Spectera

Release notes - version 1.3.0

Version 1.2.5

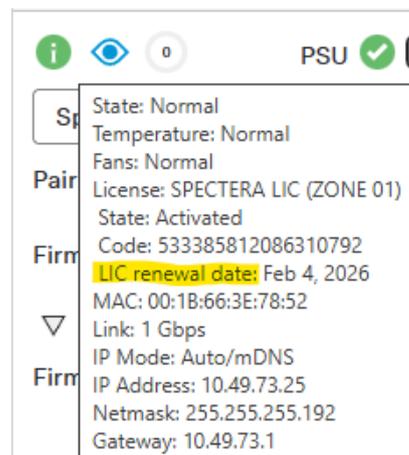
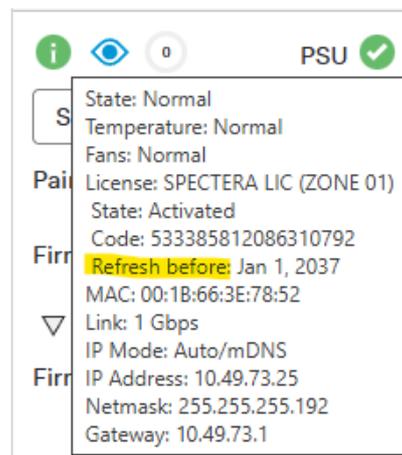
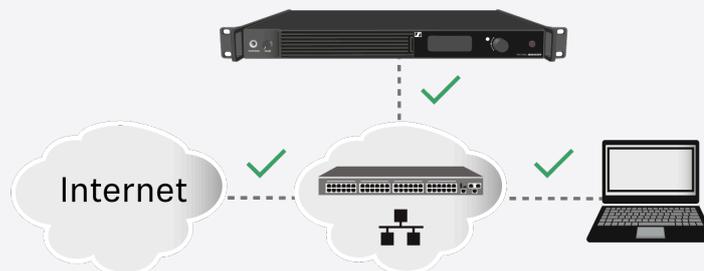
- Support for the automatic license renewal of licenses issued before November 20, 2025.

The license renewal will be displayed in the device state after some time:

Before update:

After update:
